IREDELL COUNTY HEALTH DEPARTMENT

IMPROVEMENT PERMIT / AUTHORIZATION TO CONSTRUCT / OPERATION PERMIT / EXISTING SYSTEM

APPLICANT: LAKE NORMAN YACHT CLUB APPLICANT ADDRESS: PO BOX 4600 MOORESVILLE NC 28117

SEPTIC SYSTEM SITE PLAN
LAKE NORMAN YACHT CLUB BATH HOUSE
297 YACHT ROAD
MOORESVILLE, IREDELL COUNTY, NC

AS BUILT SKETCH

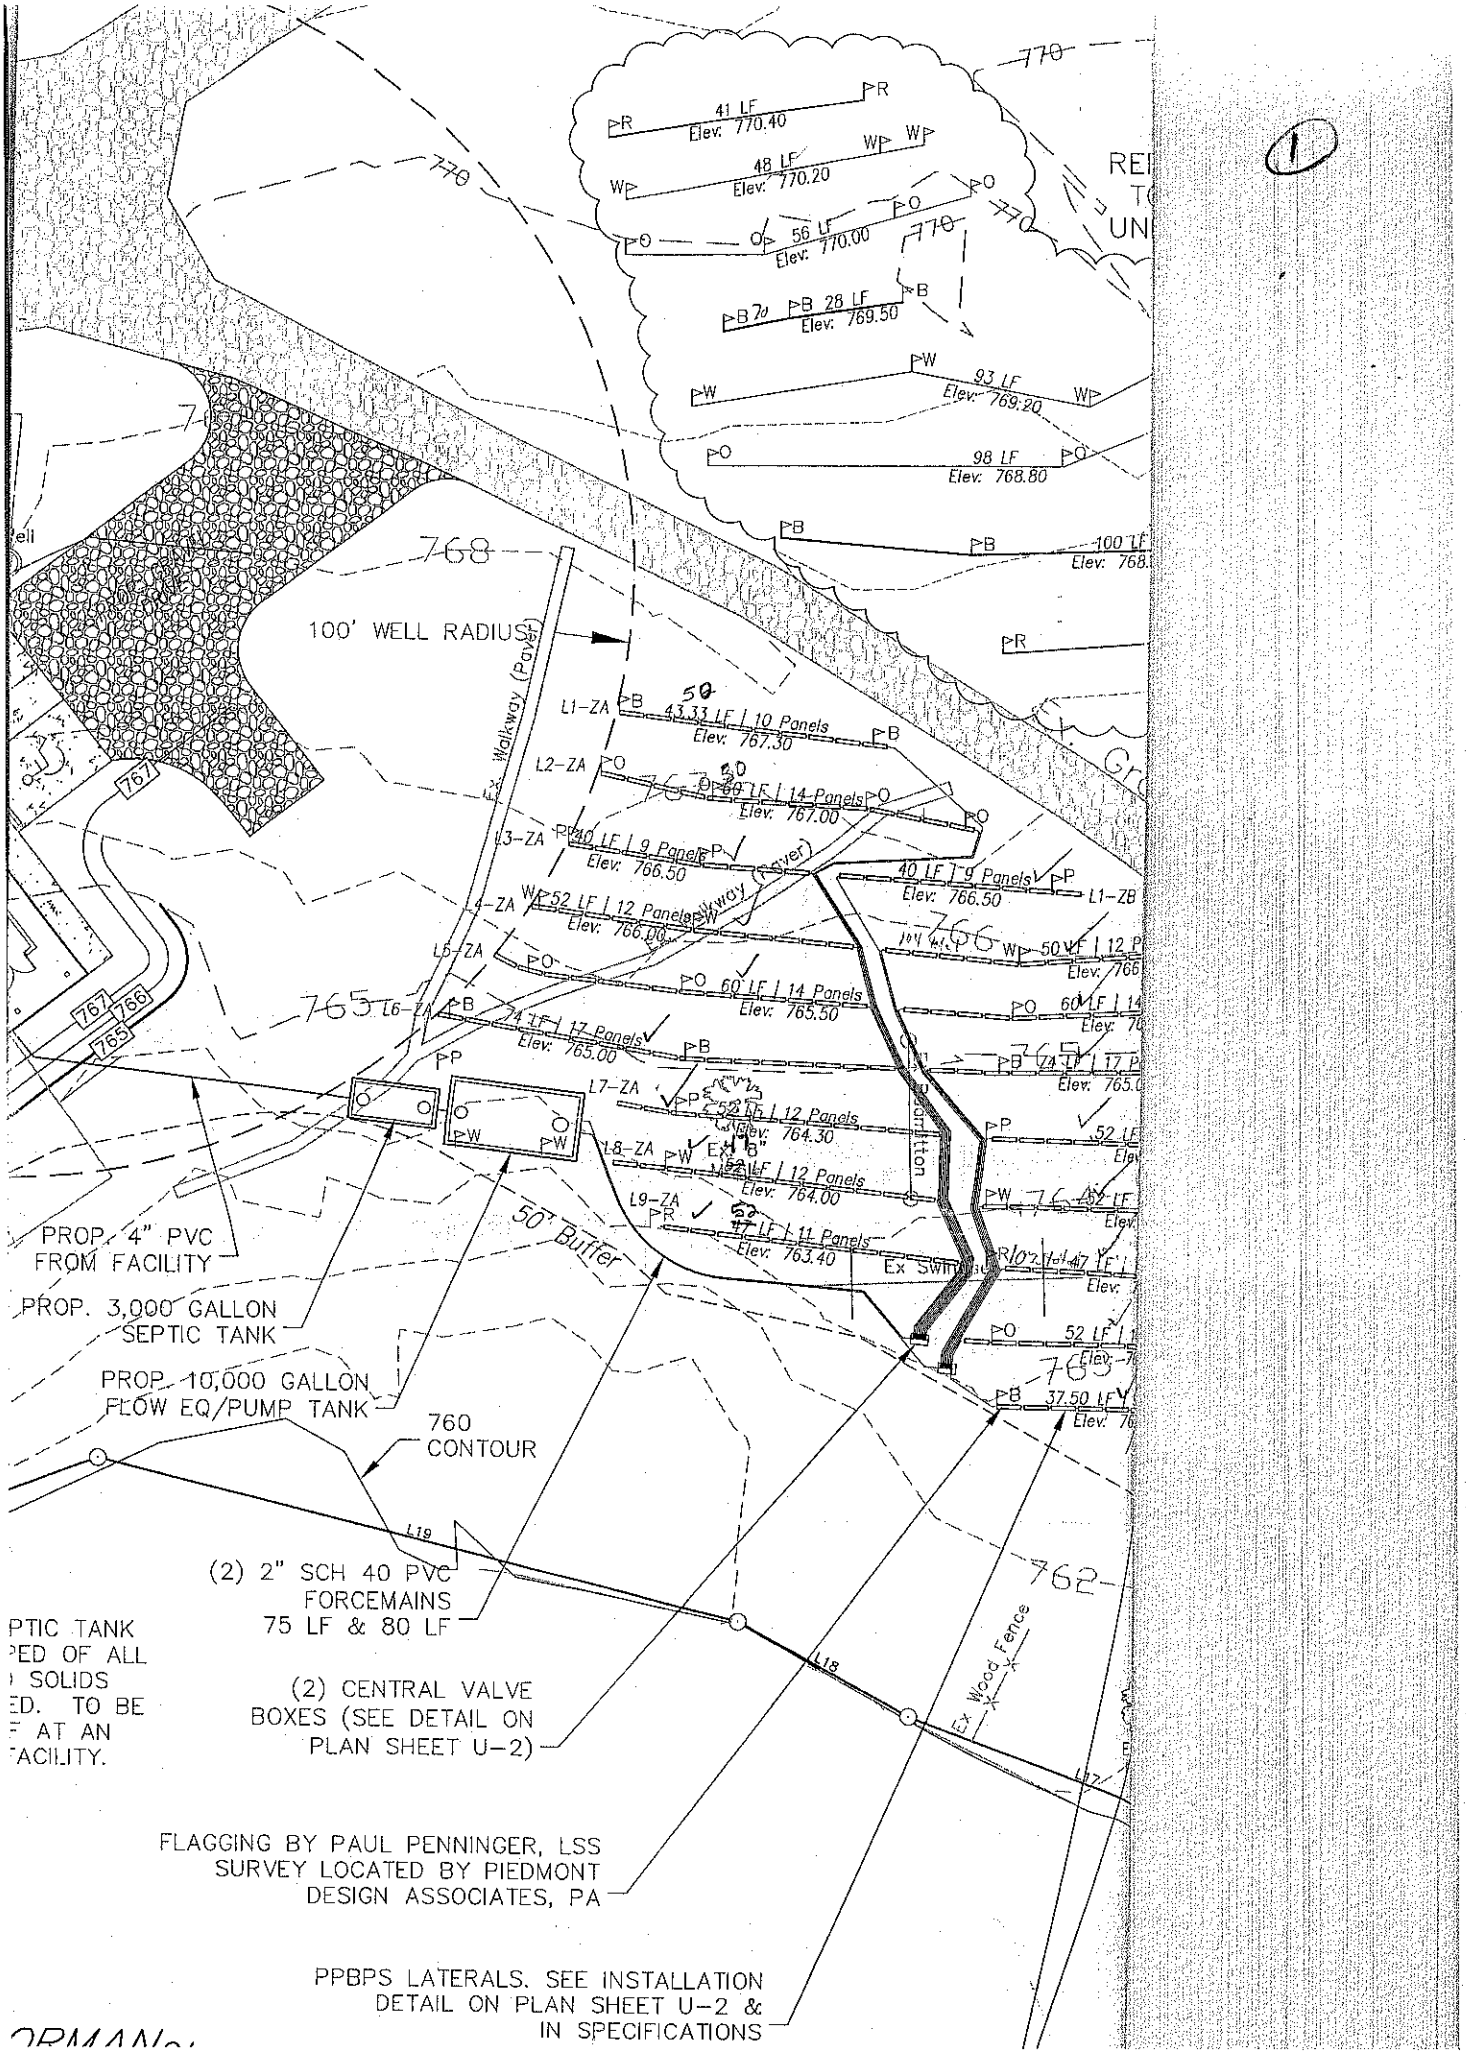
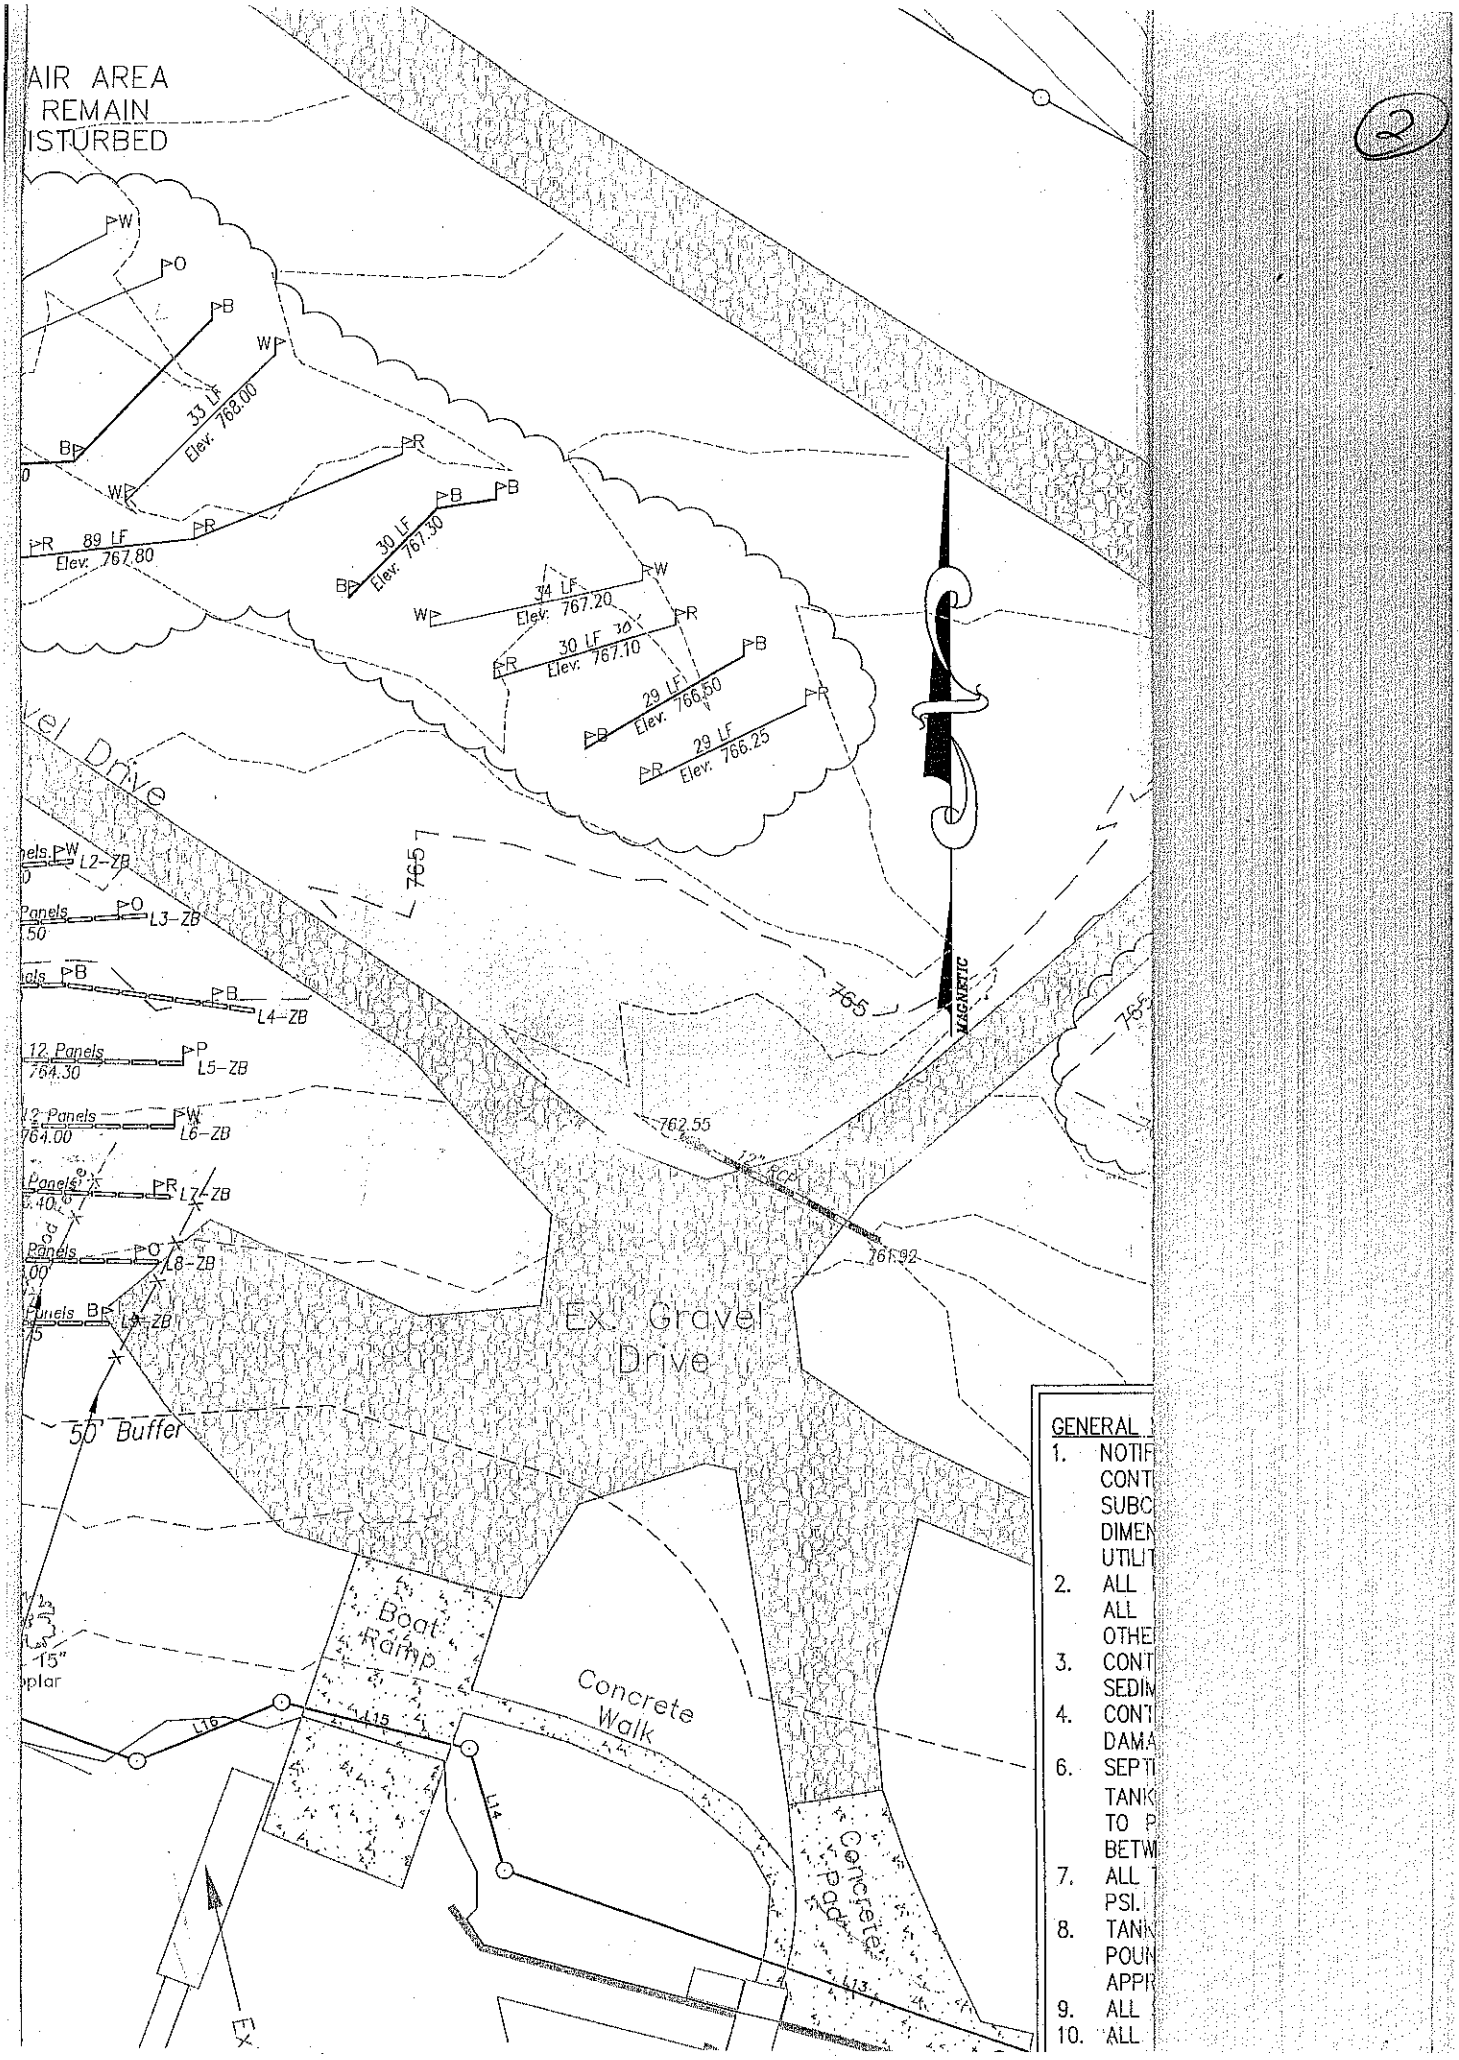
* IREDELL COUNTY ADVISED DESIGNER TO ADJUST VALVE BOX TO TOP OF FIELD BUT DECLINED. IF CHECK VALVE MALFUNCTIONS SYSTEM MAY OVERLOAD AND SURFACE.

Checked 13 lines.
Drilled 5/32" hole
11/14/14 Checked 5 lines
11/19/14 Pressure Set ~~MD~~
1/12/15 PT Riser > 6" above grade
Box > 12" above grade
Sealed, alarm & pump on Separate Circuit breakers
